Design Review Committee Meeting

5.I. Justin Honore 244 Mount Zion Road - New SF Dwelling

**DEPARTMENT OF PLANNING AND ZONING
PLANNER'S REPORT**

DATE: December 21, 2020
TO: Tonya Hutson
FROM: Lynn Patterson
RE: **Design Review – 244 Mt Zion Rd**

1/4"=1'-0"

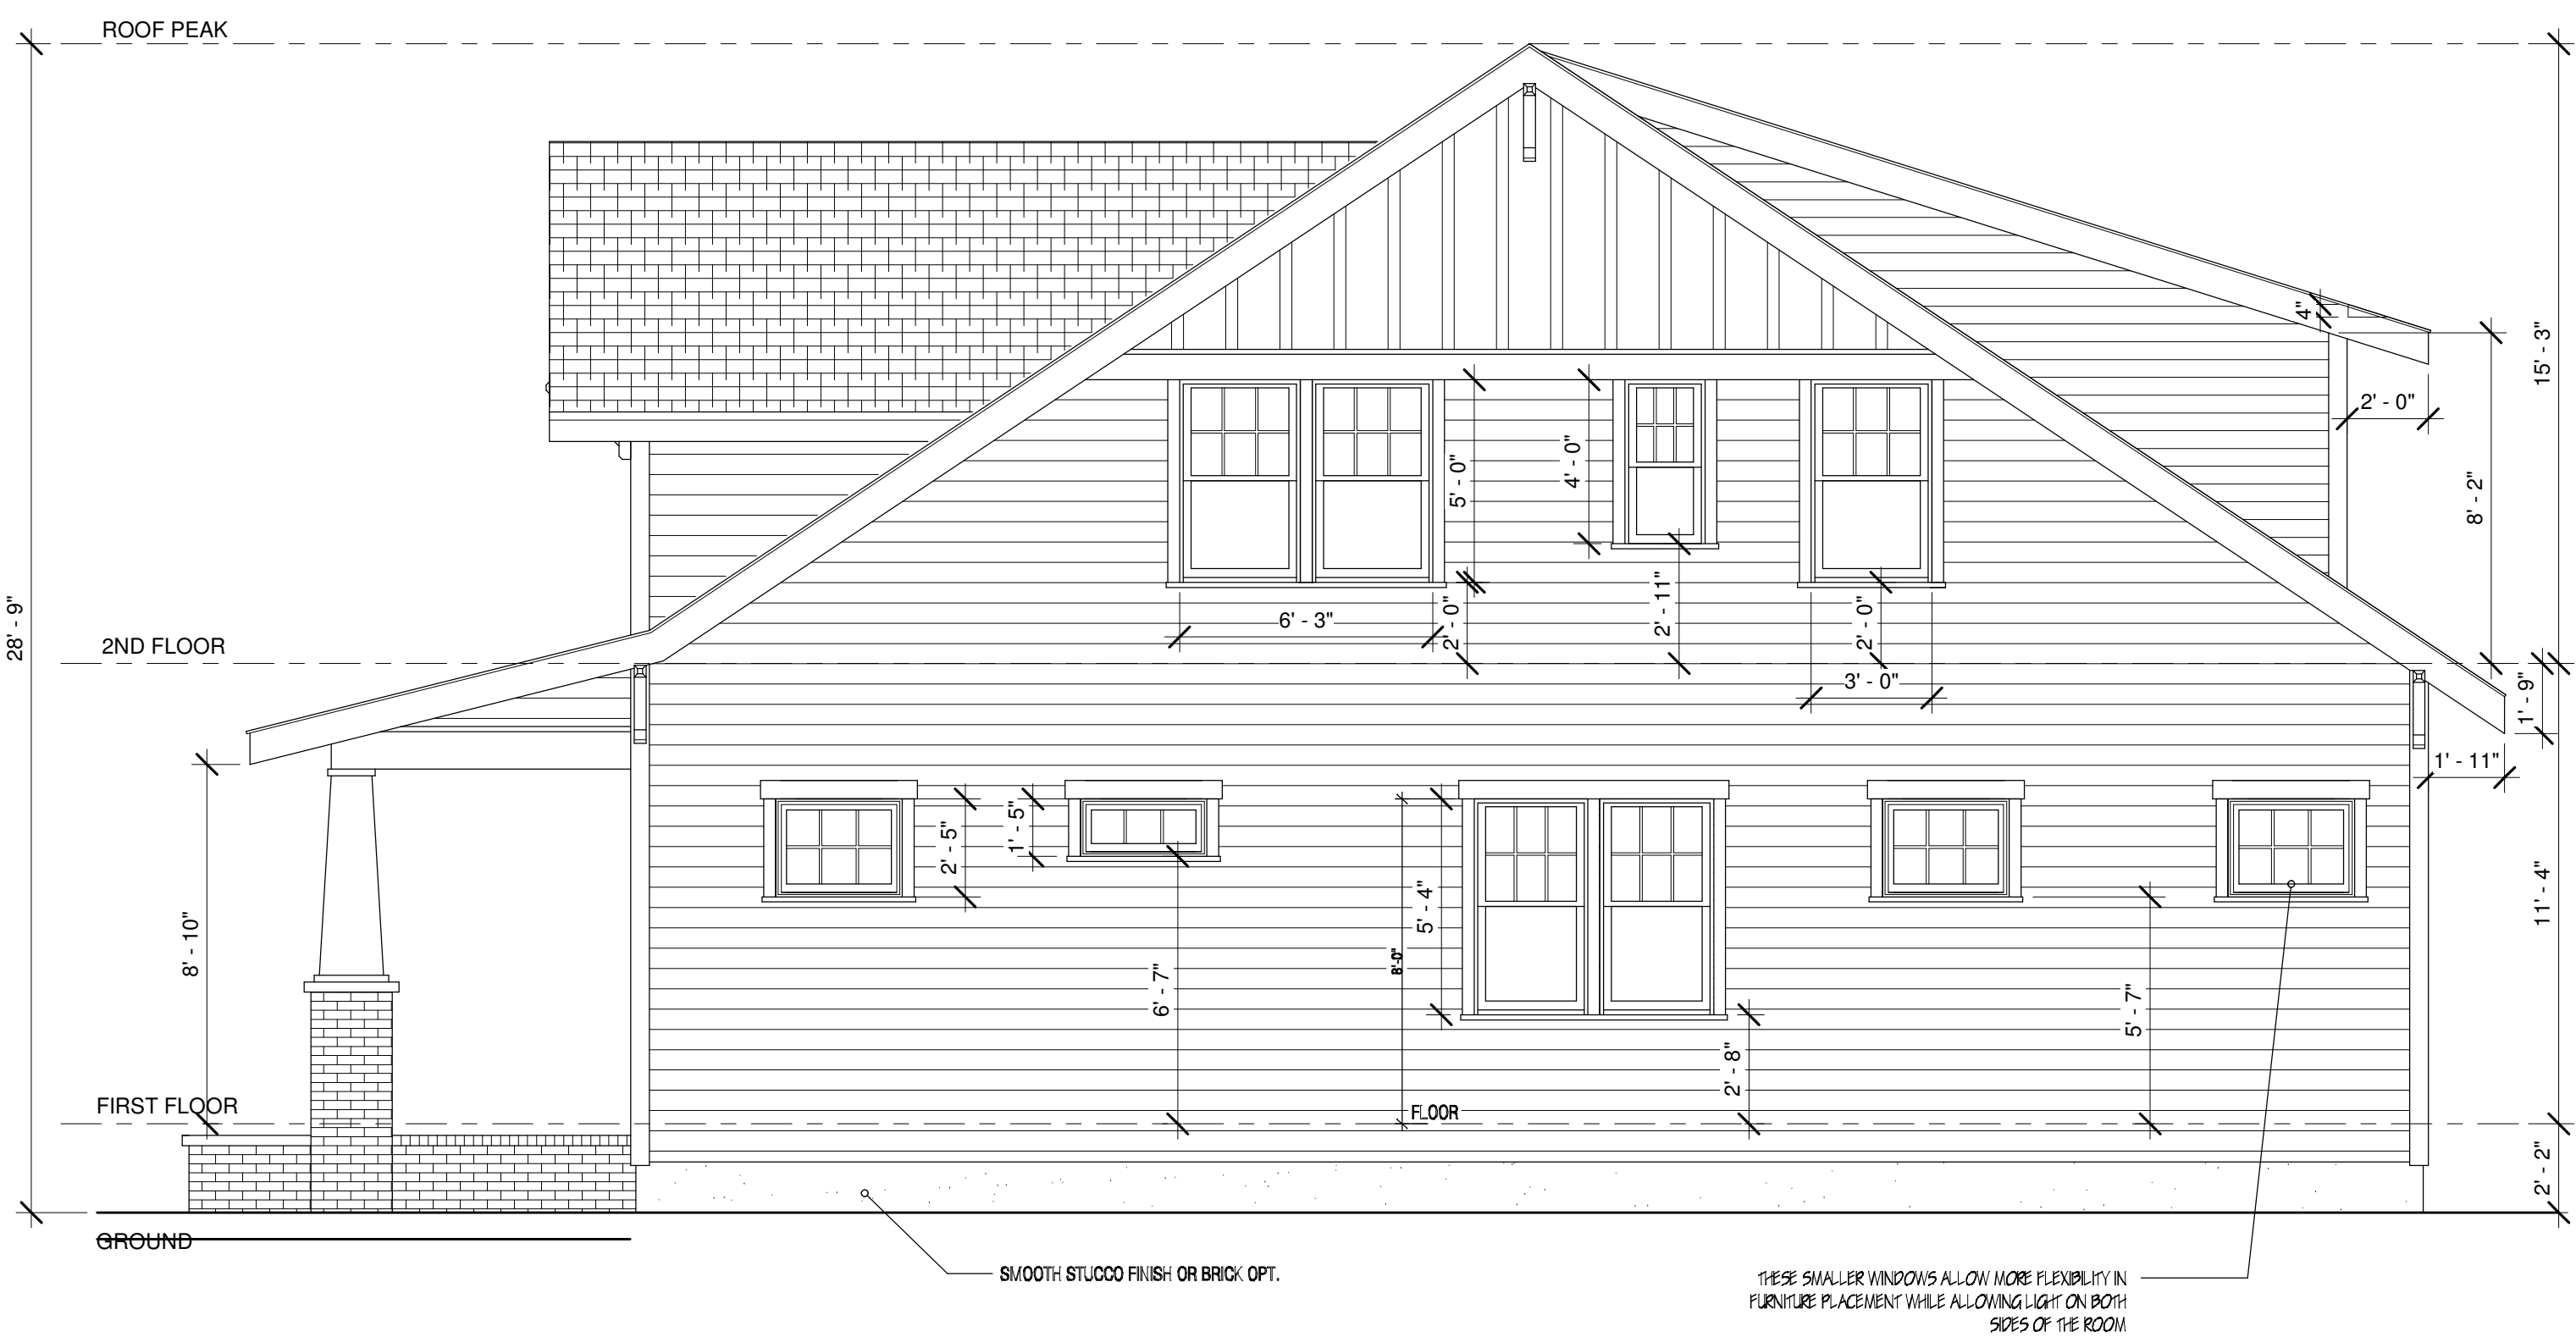
Sill height shown as 2'

- ✗ *Window Sills.* Enfronting first story window sills should be no less than two and one-half feet and no more than three and one-half feet above finished floor elevation.

Other: Sill height is 2' above ffe.

- **Provide existing retaining wall height.**
- **Window sill elevations is 2' and required to be 2 .5'. Design exception required.**
